**Re: Response to Observations – Borrisbeg Renewable Energy Development (ABP-318704-23),
Strategic Infrastructure Development (SID) Application**

Response to Observations Received

Borrisbeg Renewable
Energy Development (ABP
Ref. 318704)

Document Title: **Response to Observations Received**

Figure 1 Field of View to the west towards the Devil's Bit from R433 Regional Road in the townland of Farranderry

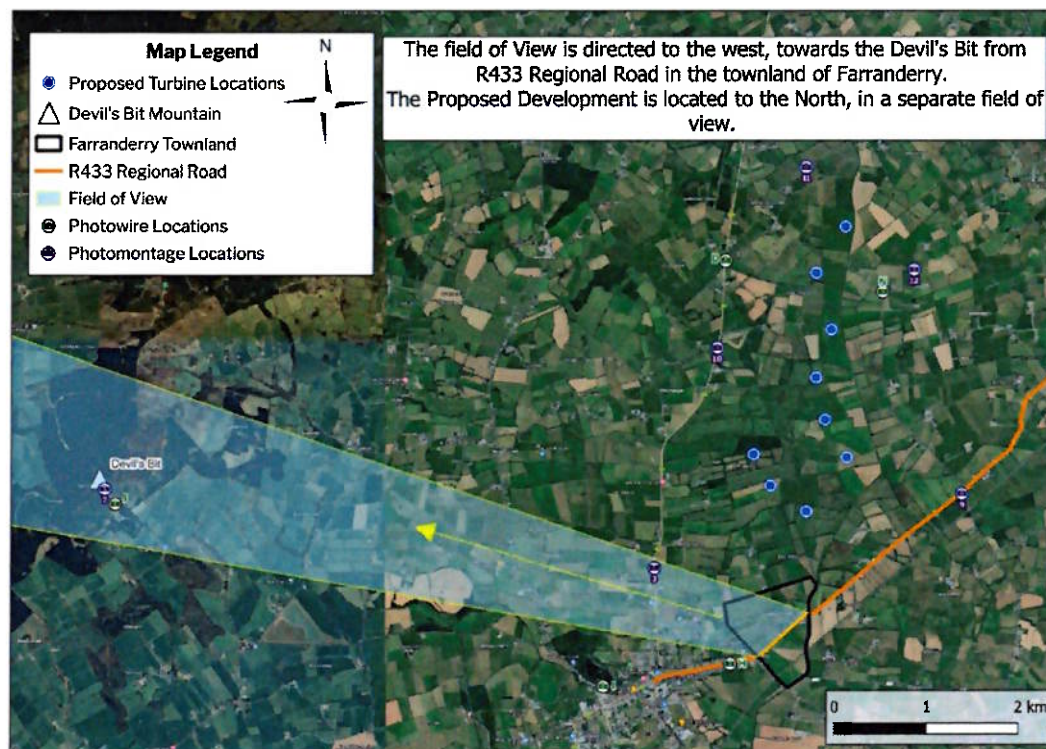
"3 - the Planning Authority considers that the impact of the development of the Devils Bit landmark has not been adequately assessed. In particular, the applicant should demonstrate that

The field of viewpoints in photomontages presented in the EIAR represent a 53.5-degree horizontal field of view. The 53.5° field of view allows for photomontages to present a 180° field of view (two 90° views side by side) and covers differing directional field of views to ensure the cumulative assessment of the landscape is shown as accurately as possible.

Figure 1 above illustrates the field of view towards Devil's Bit Mountain, a designated Secondary Amenity Area by Tipperary County Council, originating from the section of the R433 Regional Road situated within the townland of Farranderry. The field of view is orientated to the west-north-west, facing away from the Proposed Wind Farm, which is located to the north of this road section within Farranderry townland. Given the two differing viewing perspectives (to the west and to the north), there are no overlapping views where the proposed turbines will be visible simultaneously in alignment with the Devil's Bit landmark while travelling southwest towards Templemore.

Figure 15-8 Location 2 - N62 / L-3248 / site access, junction layout

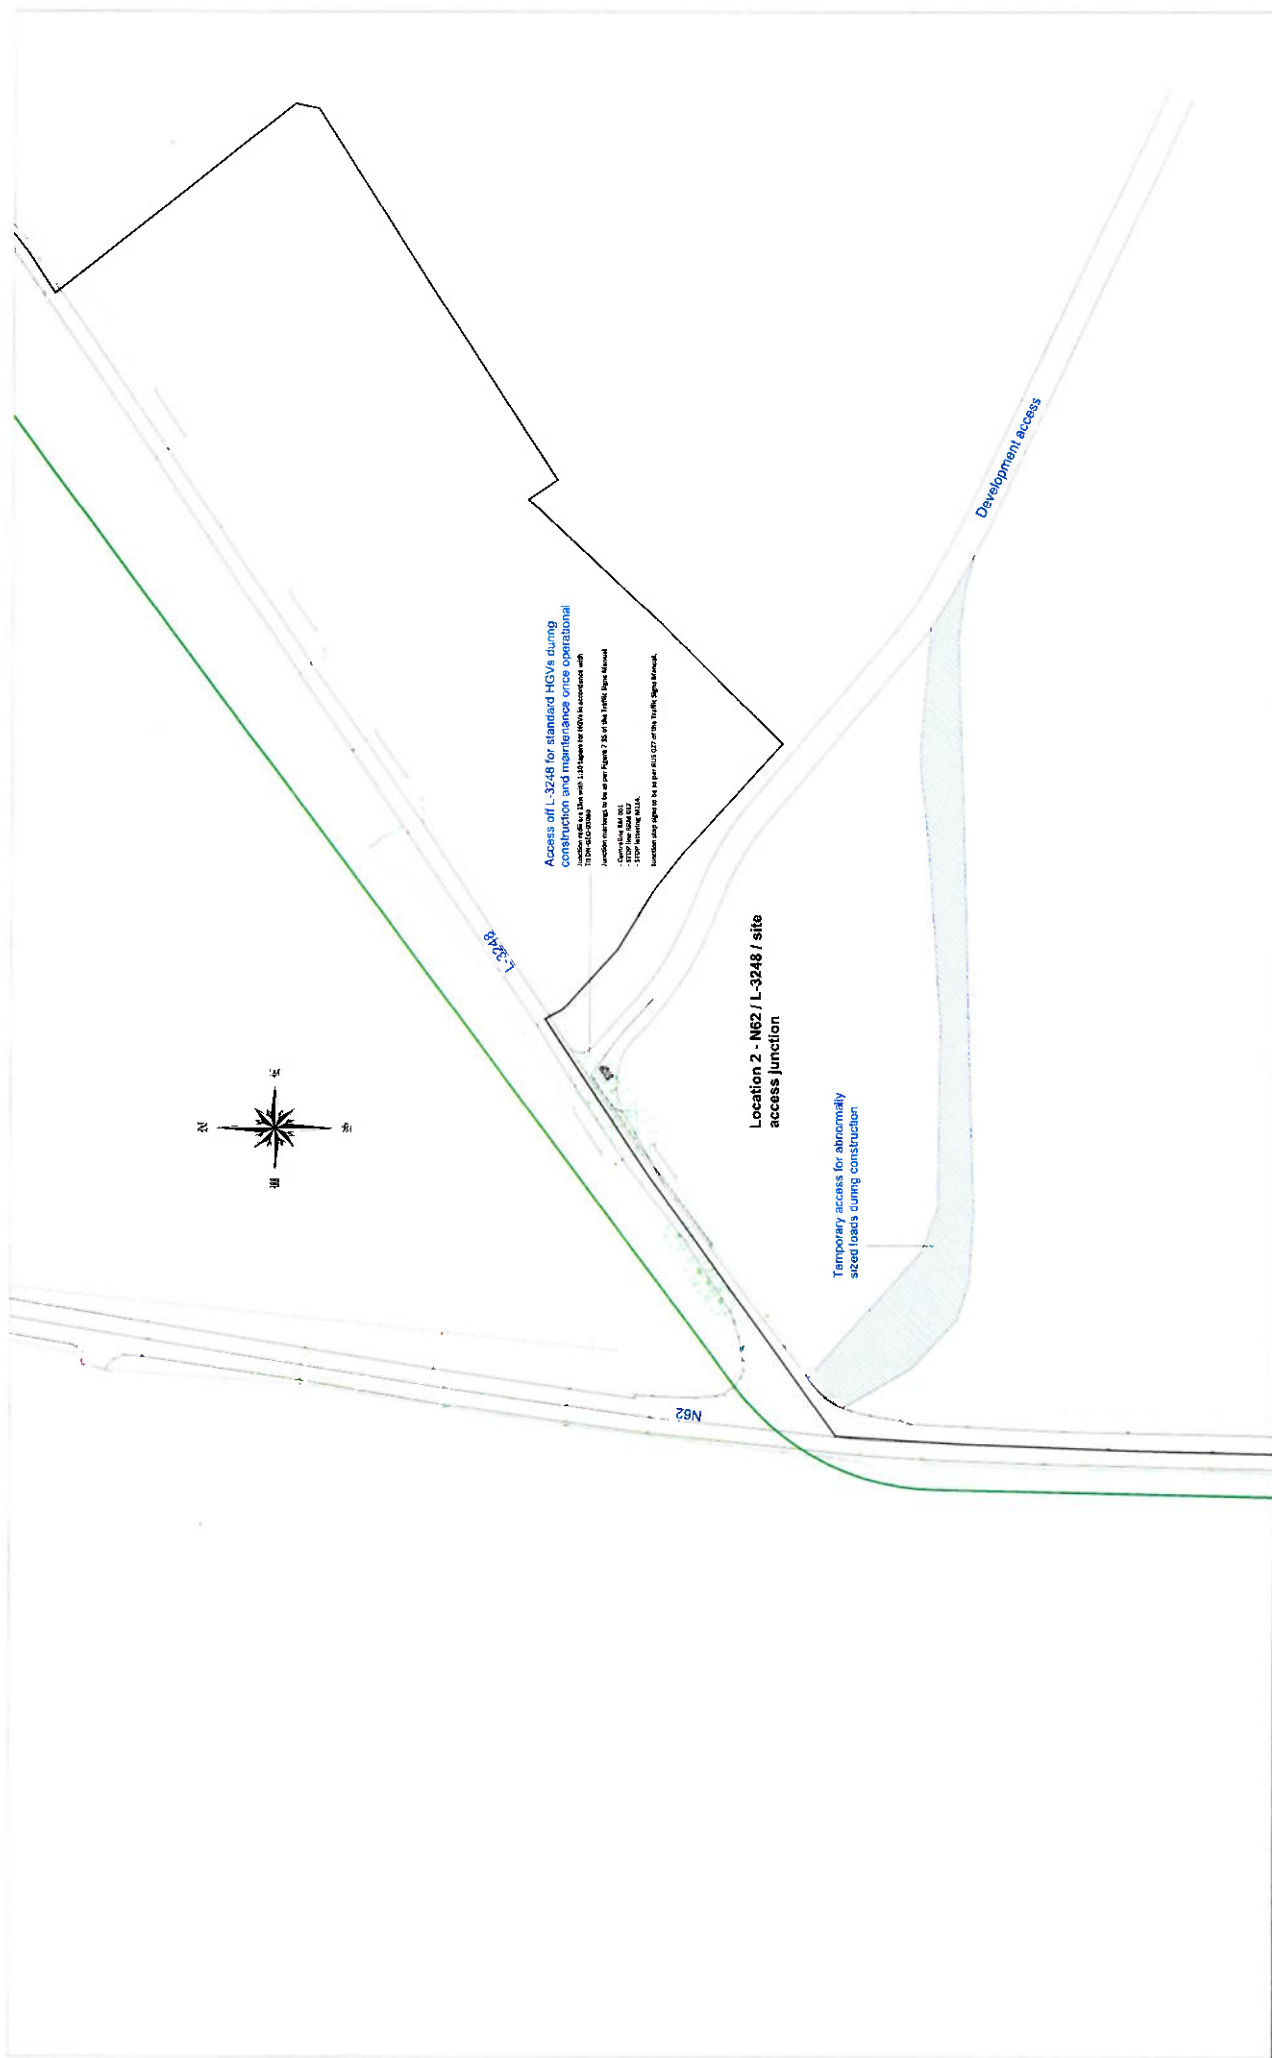
- 3) **Tipperary County Council recommend that a Stage 1 Road Safety Audit is carried out for the project with particular focus on the temporary and permanent access routes onto the public road to ensure the safety of the public road user at all times during the construction and operation of the facility. Please see section 4.4 of this Response document for Alan Lipscombe Traffic Consultants' response to Roads and Traffic issues raised by both Tipperary County Council.**

With respect to the proposed temporary access for abnormally sized loads as shown in Figure 15-8, it is proposed that the access is located on the southern side of the L-3248 directly into the junction with the N62. As stated in Chapter 15 of the EIAR, it is proposed that this access will be opened temporarily and only on designated hours on the nights that the abnormally sized vehicle convoys deliver to the Site. This access is not designed in accordance with TII Guidelines and no visibility splays are provided at this location as this is a temporary facility that will be used on the 52 nights when a convoy of 3 abnormally sized loads will be escorted into the Site by means of an escort provided by An Garda Síochána and the haulage company. On these nights, transient traffic management will also be provided on the N62 and L-3248. At all other times during the construction period this access will be closed off by means of a gate. On the completion of the construction phase this location will be fenced off and re-instated to its original state. Should the temporary access for abnormally sized loads be required during the operational or decommissioning phases of the Proposed Wind Farm, it will be re-opened and managed in the same manner as outlined for the construction phase.

As part of the introduction of the proposed temporary access road for the delivery of abnormal loads, as shown in Figure 15-8, there are no changes proposed to the horizontal alignment on the N62, or the L-3248 approach to the junction with the N62.
